16075

## **Shell Cove Section 75W Concept Plan MP 07\_0027 (Mod 1) Removal of Acoustic Mounds and Draft Condition B1**

**Figure 1 Indicative Residential and BMF Built Form (refer Attachment 2 for larger version)**

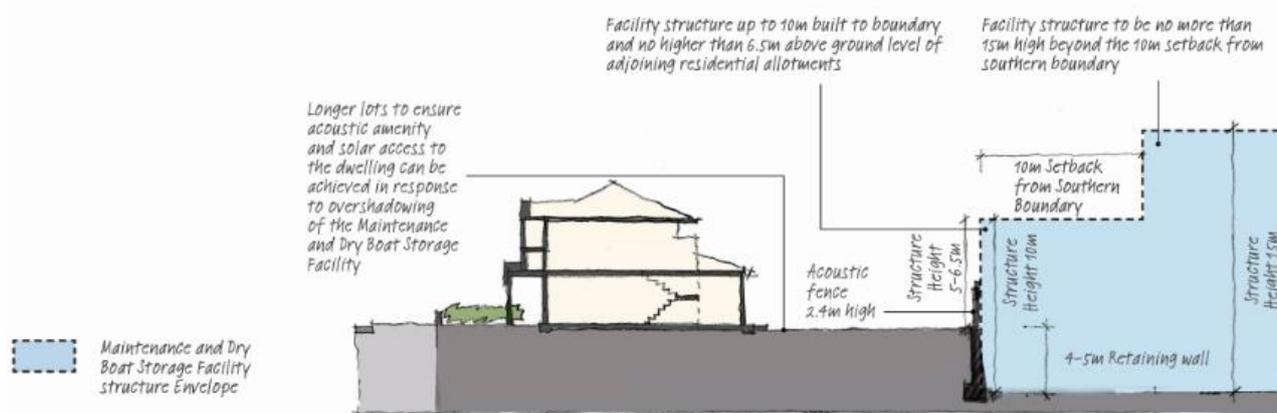
As part of the development of the controls for Precinct A the Urban Design Guidelines required an acoustic wall and landscape setback to the BMF. A typical cross section between the BMF and the residential dwellings to the south is shown in **Figure 1**.

We are of the opinion that that the inclusion of a 5 metre landscape buffer, within the BMF land but level with the residential land, is likely to result in confusion over the ownership and future maintenance of the landscape buffer. The landscaped zone is therefore much better located within a residential lot in order that the home owner can maintain the landscape buffer and effectively utilise the open space as part of their lot.

- (a) provided on land associated with the ~~marina / commercial land use~~ **residential land uses** and be located south of the acoustic wall;*
- (b) must include appropriate planting to screen the acoustic wall from the residential properties to the south; ~~and~~*
- (c) must have the same ground level as the residential properties ~~to the south;~~*
- (d) be included in the section 88B instrument as a restriction on built form within 5m of the acoustic wall; and***
- (e) be included in the section 88B instrument in the form of a positive covenant, requiring the maintenance of the vegetation specified in (b) above.***
